CITY OF ALBUQUERQUE

August 29, 2023

RE: **Lot 12 Block 11 Unit 5 SAD 227**
7908 Emerald Dr. NW
Volcano Cliffs Subdivision
Grading and Drainage Plan
Engineers Stamp Date 8/28/2023 (E10D126)

ENGINEER'S SEAL DAVID SOULE NEW MEXICO REGISTERED PROFESSIONAL ENGINEER 14522 8/28/23	LOT 12 BLK 11 UN 5 VC 7908 EMERALD DR. GRADING AND DRAINAGE PLAN Rio Grande Engineering P.O. BOX 53924 ALBUQUERQUE, NM 87199 (505) 321-9099	DRAWN BY DEM
		DATE 8-26-23
DAVID SOULE P.E. #14522		SHEET # C1
		JOB #

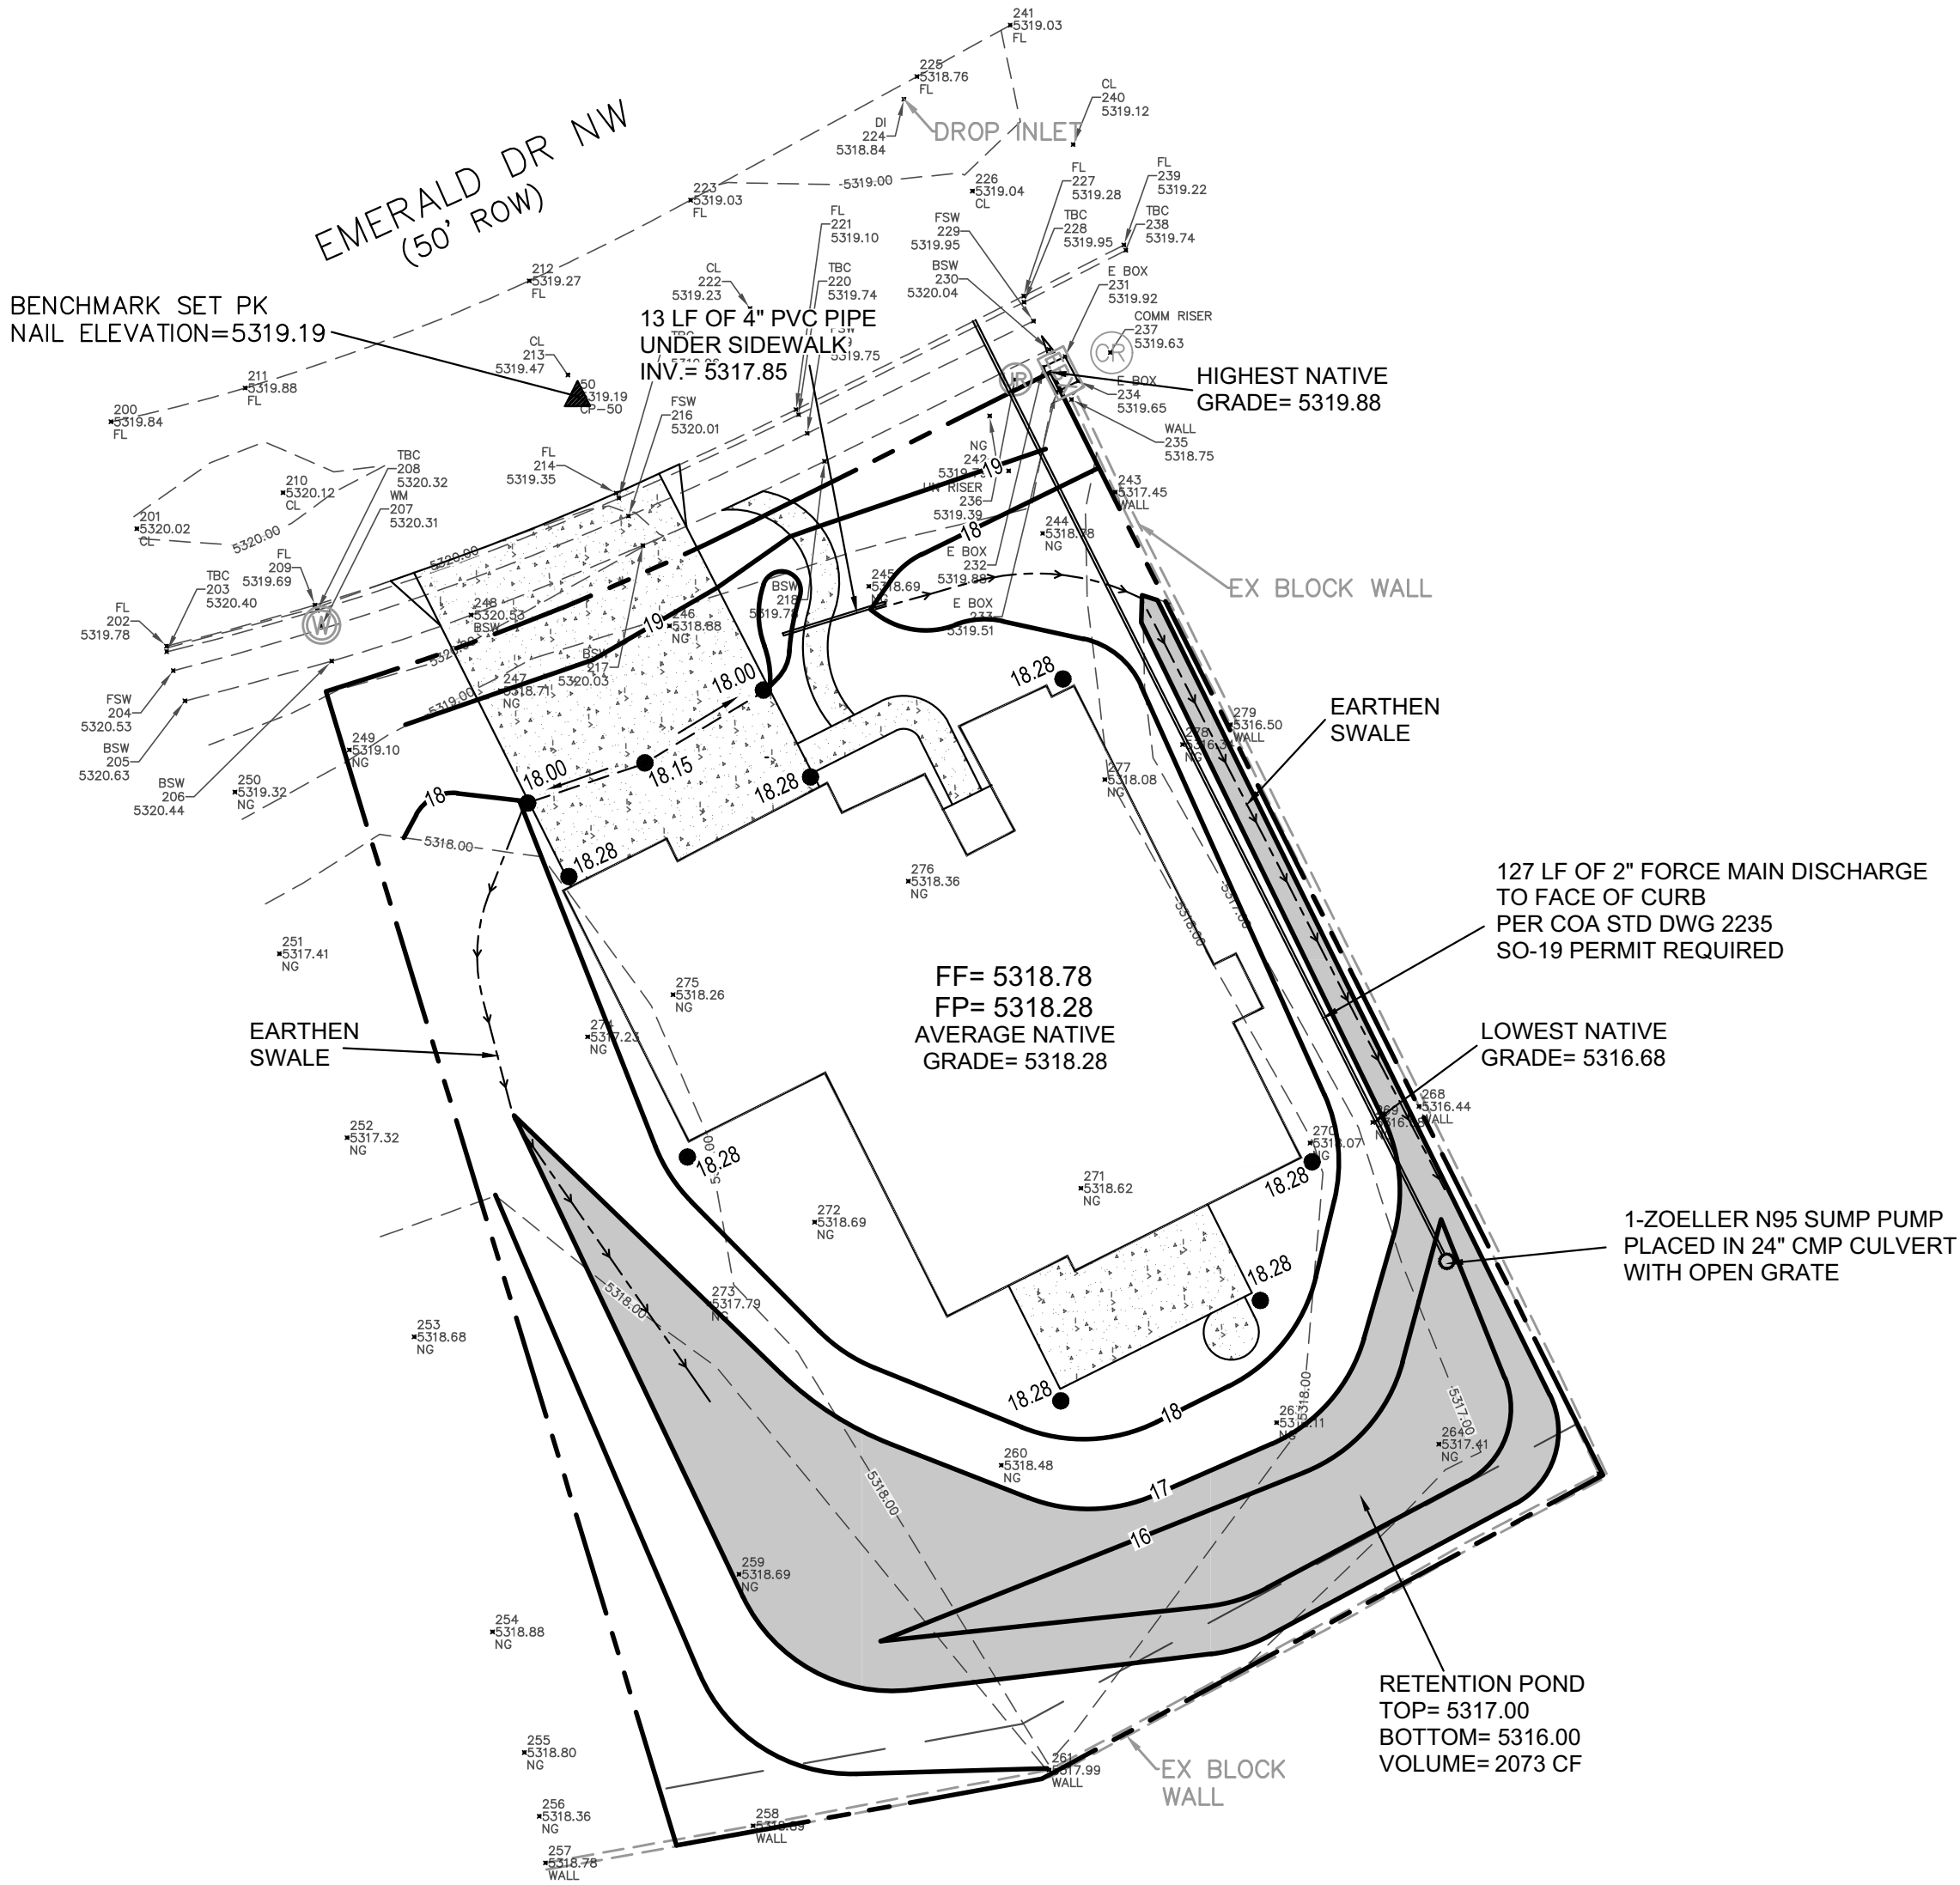
Prior to Building permit approval a Pad Certification will be required, provided by the Engineer or a registered Land Surveyor.

Advise the owner contractor not to use dirt as a ramp to climb the curb, use lumber or crusher fines for this purpose. Place this note on the plan.

Reiterate to the Owner/Contractor that a separate permit for a garden/retaining wall must be obtained with the approved G&D plan and Pad Certification. Also, if a swimming pool is to be placed after this approval a new grading and drainage plan will need to be resubmitted showing the changes for the land treatments.

Prior to Certificate of Occupancy release, Engineer Certification per the DPM checklist is required.
